Parkway Subdivision Project Questions/ Answers

Sanitary Sewer Collection System

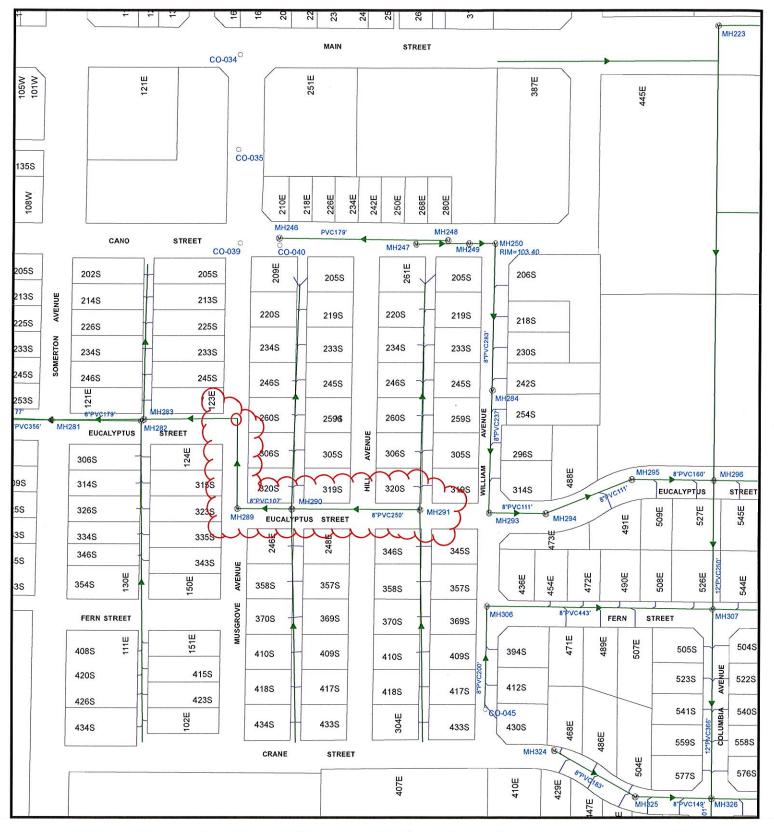
- 6. Do you have something that tell us exactly what sewer and manholes are to be replaced? See map attached
